## Re: 114 Richmond Road – Byron Avenue Access City Comments & Responses

This letter has been prepared to address the comments received from the City of Ottawa, dated February 11, 2022, with corresponding responses from Parsons.

### Re: Q West (114 Richmond Road) – Phase 2 Driveway Connection

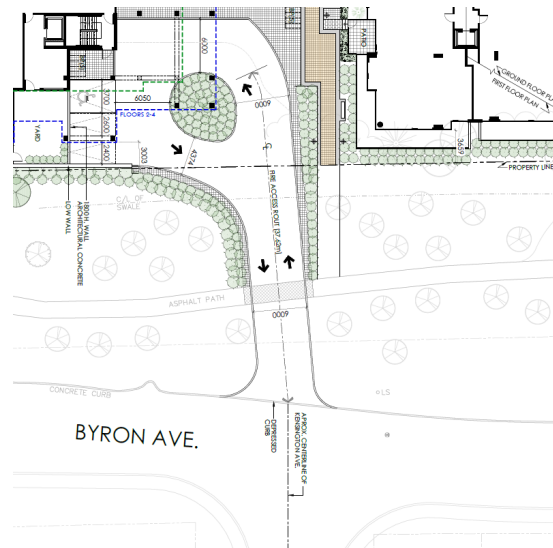
**Comment 1:** With the proposed access for Phase 2B crossing the Byron linear park and connecting to Byron Avenue at Kensington Drive, priority should be given to pedestrians and cyclists using the MUP. Consider a raised crossing and indicate the planned control at the new crossing of the existing MUP for the access to Byron Avenue.

**Response 1:** The driveway approach is expected to be stop controlled. The Byron MUP is offset over 10m from the curb-line, which provides ample space for drivers to complete the right-turn and react to a cyclist or pedestrian. The applicant will consider other visual cues, such as signage and pavement markings/treatments to enhance safety of the crossing, and possibly a raised crossing. These elements will be confirmed during the detailed design.

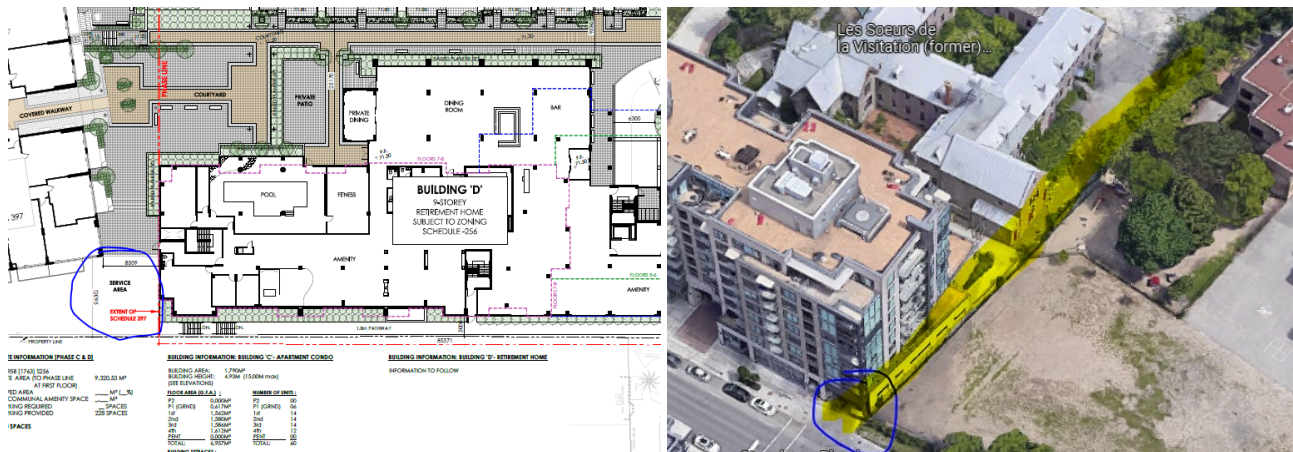
**Comment 7:** Indicate where loading will occur. If it is from the proposed Byron Avenue access, provide turning templates and ensure that there are no resulting issues in turning for larger vehicles due to the existing speed table on Byron Avenue just east of the proposed site access location

**Response 7:** Loading will occur at the basement access located at the north end of Building D, accessed from an existing connection on Richmond Road. Loading will not be accessed via Byron Ave.

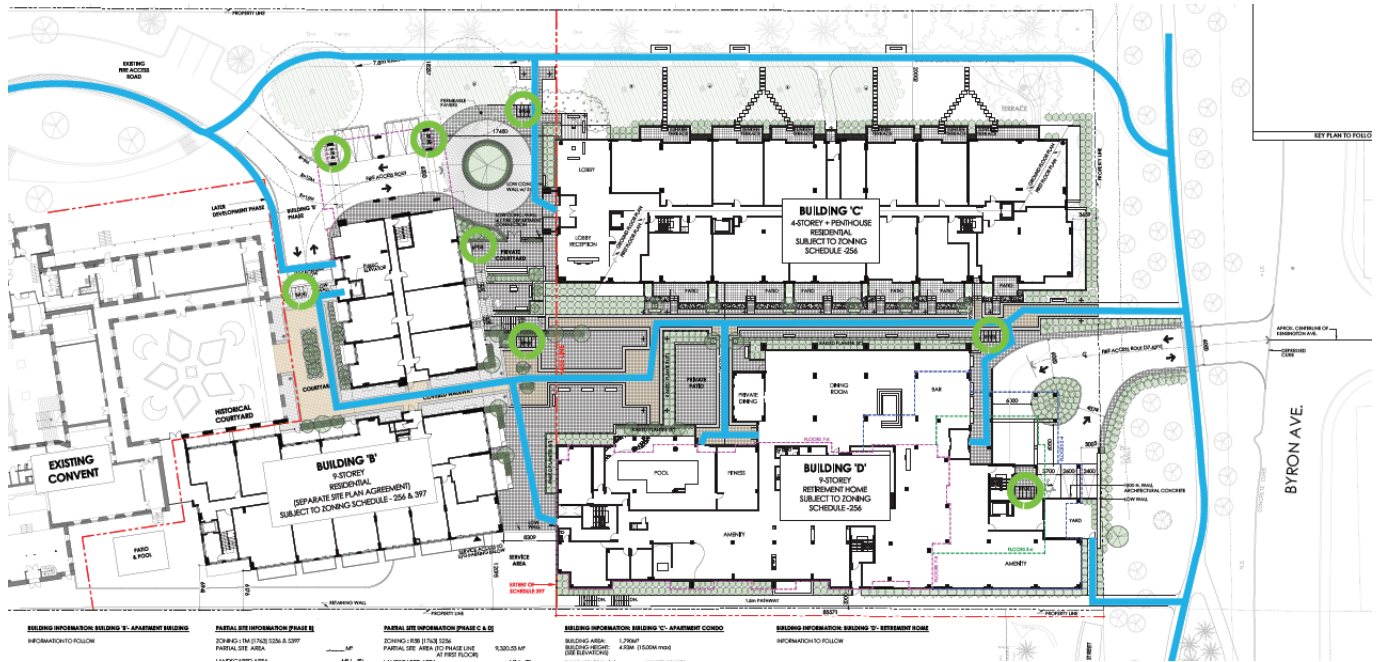
**Comment 9:** On the site plan, provide access and underground parking ramp grades. Also indicate clearly the location of the aboveground bike parking spaces.

**Response 9:** Proposed aboveground bike parking spaces have been identified in the following image (green circles). There are no longer any exterior ramps to the underground parking, all ramping is within the buildings.

**Response 16:** The image above (from Comment 9) outlines accessible pedestrian connections (blue lines), which extend from Byron Ave to Richmond Rd with linkages provided to Buildings C and D, including an accessible route through the courtyard which uses a public elevator.
